C. Design activities undertaken by individual identified in Section B. [Building Code Table 3.5.2.1 OF Division C]			
<input type="checkbox"/> House <input type="checkbox"/> Small Buildings <input type="checkbox"/> Large Buildings <input type="checkbox"/> Complex Buildings <input checked="" type="checkbox"/> HVAC – House <input type="checkbox"/> Building Services <input type="checkbox"/> Detection, Lighting and Power <input type="checkbox"/> Fire Protection <input type="checkbox"/> Building Structural <input type="checkbox"/> Plumbing – House <input type="checkbox"/> Plumbing – All Buildings <input type="checkbox"/> On-site Sewage Systems			
Description of designer's work HEAT LOSS / GAIN CALCULATIONS DUCT SIZING RESIDENTIAL MECHANICAL VENTILATION DESIGN SUMMARY RESIDENTIAL SYSTEM DESIGN per CSA-F280-12		Model: 2009 Project: CENTREFIELD (WEST GORMLEY)

SITE NAME: CENTREFIELD (WEST GORMLEY) DATE: Apr-21 DATE: Apr-21 DATE: Apr-21
BUILDER: ROYAL PINE HOMES TYPE: 2009 GFA: 1660 LO# 87532 LO# 87532 LO# 87532
WINTER NATURAL AIR CHANGE RATE 0.236 SUMMER NATURAL AIR CHANGE RATE 0.072 HEAT LOSS AT °F. 78 HEAT GAIN AT °F. 13 CSA-F280-12 SB-12 PERFORMANCE

RESIDENTIAL MECHANICAL VENTILATION D

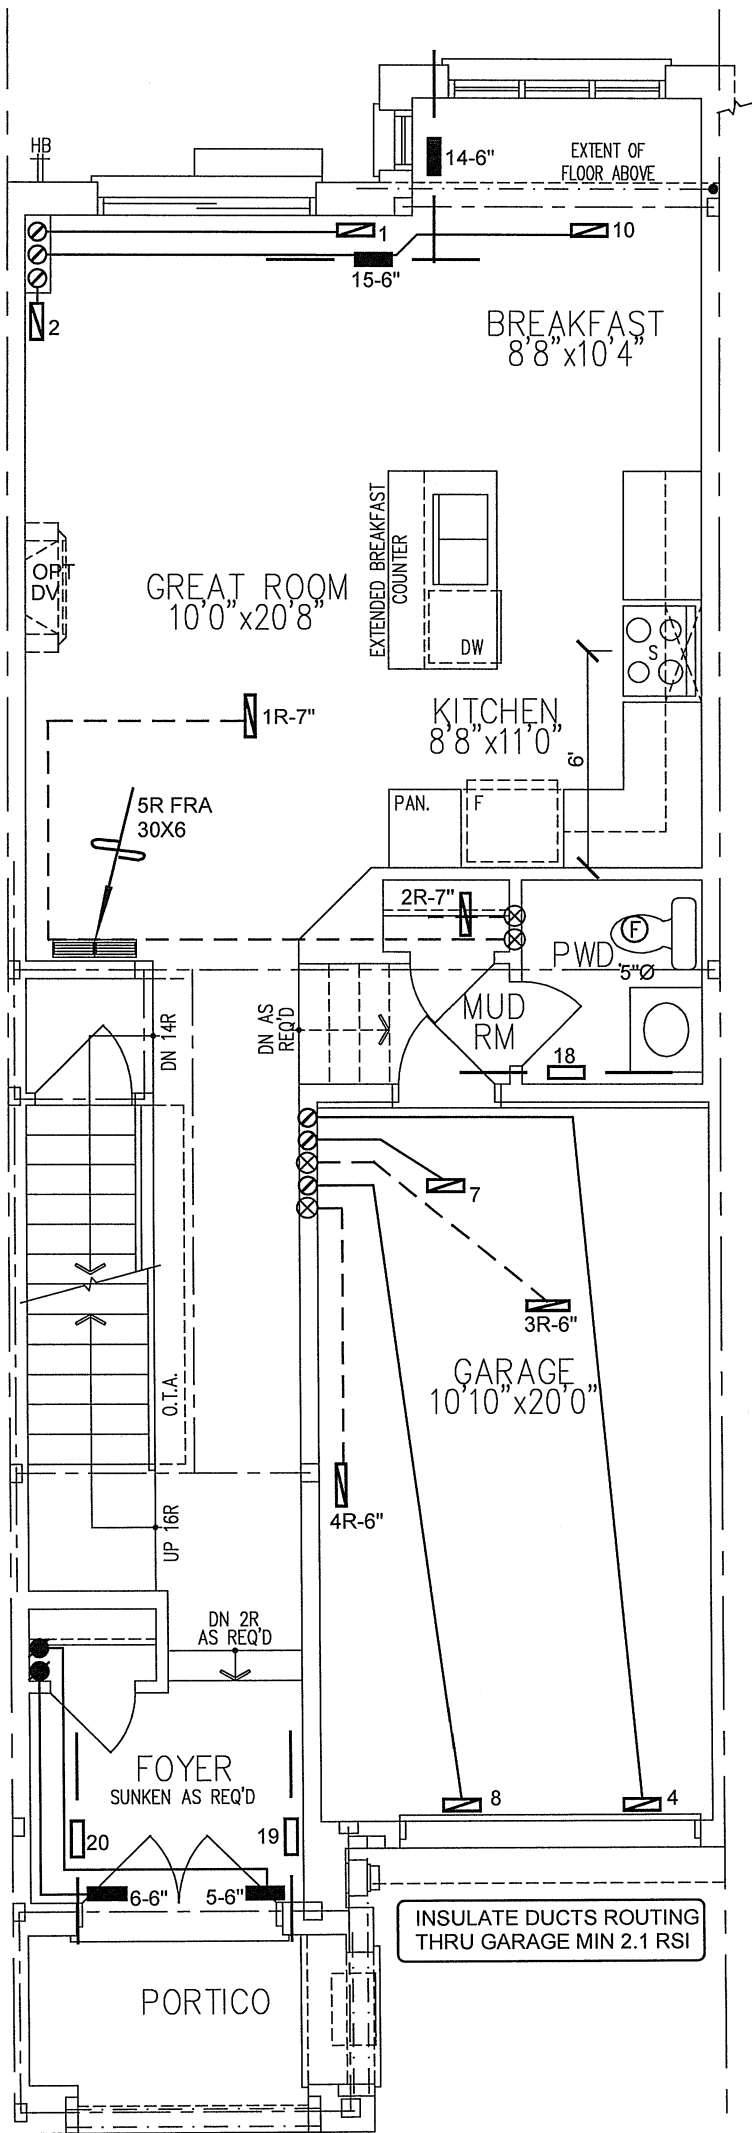
require air tightness
test as per energy
modelling

GROUND FLOOR PLAN, EL. 'B'

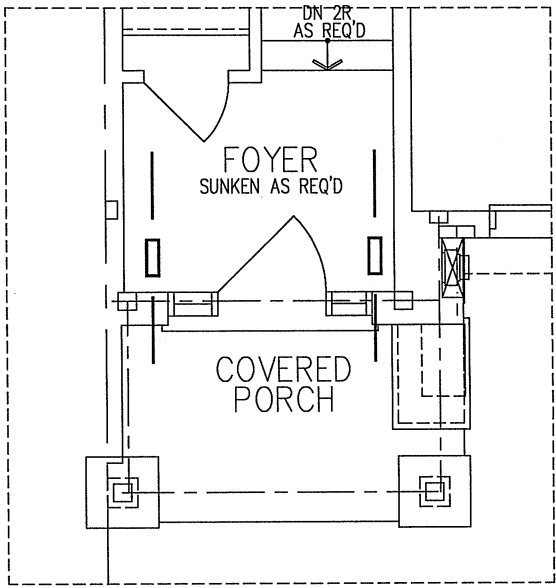
Space between studs and joists used as return ducts shall be separated from unused portion as per OBC 2012 Div.B 6.2.4.7(6)

Kitchen hood exhaust duct shall be provided as per OBC 2012, Div.B 9.32.3.10, 9.32.3.5(2).

SECOND FLOOR PLAN, EL. 'A'

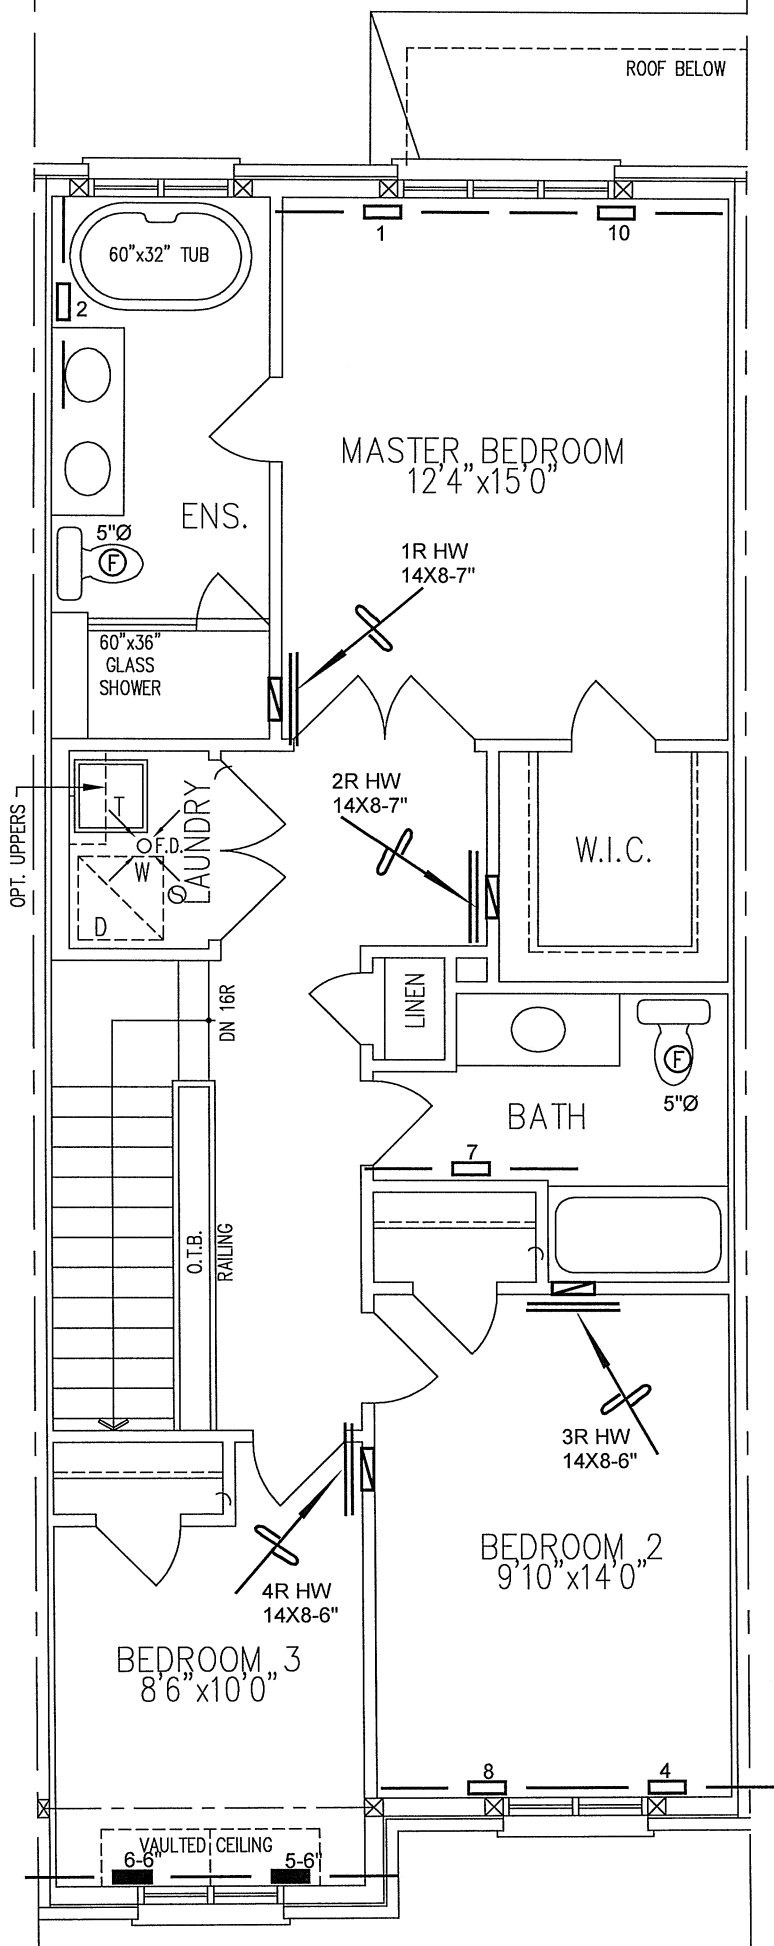
Space between studs and joists used as return ducts shall be separated from unused portion as per OBC 2012 Div.B 6.2.4.7(6)

Laundry dryer exhaust duct shall be provided as per OBC 2012 Div.B 6.2.3.8(7).
